**CITY PLAN COMMISSION****THURSDAY, MAY 8, 2025****FILE NUMBER:** S245-144**SENIOR PLANNER:** Hema Sharma**LOCATION:** between Arapaho Road and La Cosa Drive, east of Meandering Way**DATE FILED:** April 9, 2025**ZONING:** R-7.5(A)**CITY COUNCIL DISTRICT:** 11**SIZE OF REQUEST:** 13.9355-acres**APPLICANT/OWNER:** Richardson Independent School District

**REQUEST:** An application to create one 13.9355-acre lot from a tract of land in City Block 10/8916, and to dedicate right-of-way and easements on property located between Arapaho Road and La Cosa Drive, east of Meandering Way.

PRELIMINARY PLAT  
OF  
WJHS ADDITION  
LOT 1R, BLOCK 10/8196  
REPLAT  
OF  
RICHARDSON HEIGHTS ESTATES WEST  
TRACT A, BLOCK 10/8196  
JOHN BECKWELL, SURVEY, ABSTRACT NO. 53  
CITY OF DALLAS, DALLAS COUNTY, TEXAS  
CITY PLAT FILE NO. S245-144  
ENGINEERING NO. DP-  
SCALE: 1" = 30'  
DATE: APRIL 2025

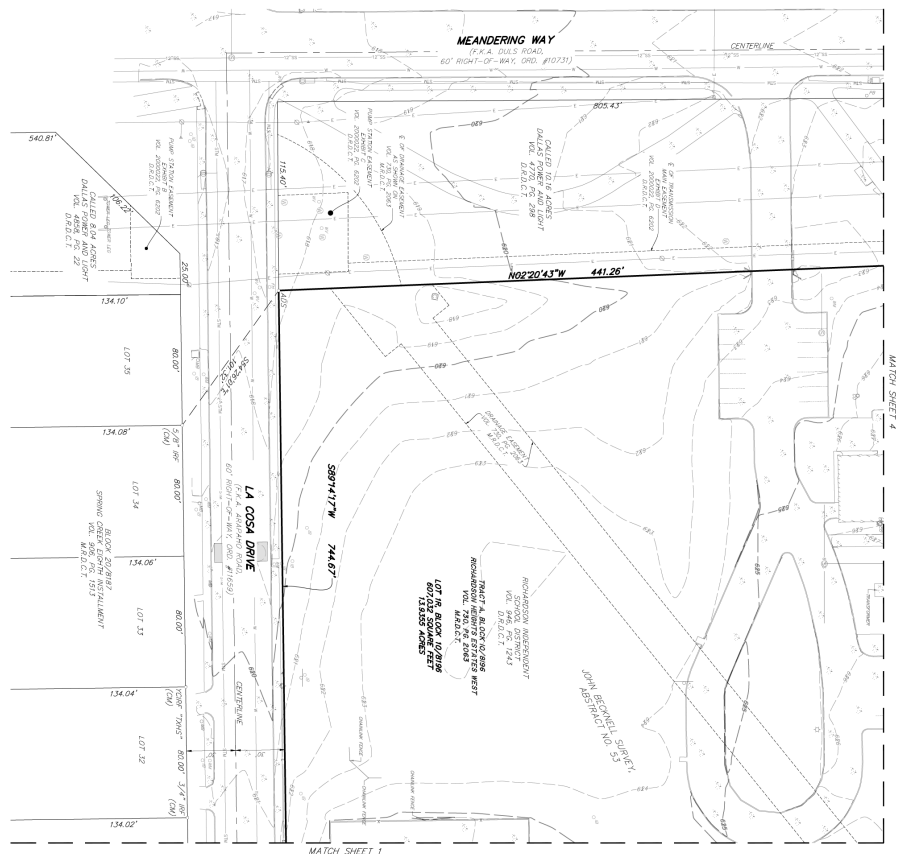
16. On the final plat, dedicate 50 feet of right-of-way (via fee simple) from the established center line of Arapaho Road. *Section 51A 8.602(c)*
17. On the final plat, dedicate a 15-foot by 15-foot Alley Sight Easement at the intersection of Arapaho Road & the alley. *Section 51A-8.602(e)*
18. On the final plat, dedicate a 15-foot by 15-foot Alley Sight Easement at the intersection of La Cosa Road & the alley. *Section 51A-8.602(e)*

19. Prior to final plat, submit a completed final plat checklist and all supporting documents.
20. On the final plat, show recording information on all existing easements within 150 feet of the property.

21. Additional design information is required for assessment. Site plan must be submitted showing proposed development, building finished floor elevation, development, existing mains – including downstream manhole, and proposed water and wastewater service locations. Submit water/wastewater engineering plans to 320 E. Jefferson Blvd., Room 200, Attention: Water and Wastewater Engineering.
22. Water main improvements may be required by Private Development Contract. Submit water/wastewater engineering plans to 320 E. Jefferson Blvd., Room 200, Attention: Water and Wastewater Engineering.
23. Existing and any proposed Water and Wastewater Easements must be shown and/or increased to conform to current design standards. **Notice:** Minimum DWU easement size 20' for one utility and 25' for both water and sewer. Larger diameter or deeper mains may require additional width.

24. Prior to final plat, compliance with City's street lighting standards including illumination standards, material, installation, and activation per Street Design Manual.
25. On the final plat, change "La Cosa Drive (FKA Arapaho Road)" to "La Cosa Drive (FKA Old Arapaho Road)". Section 51A-8.403(a)(1)(A)(xii).
26. On the final plat, identify the property as Lot 47 in City Block 10/8196.
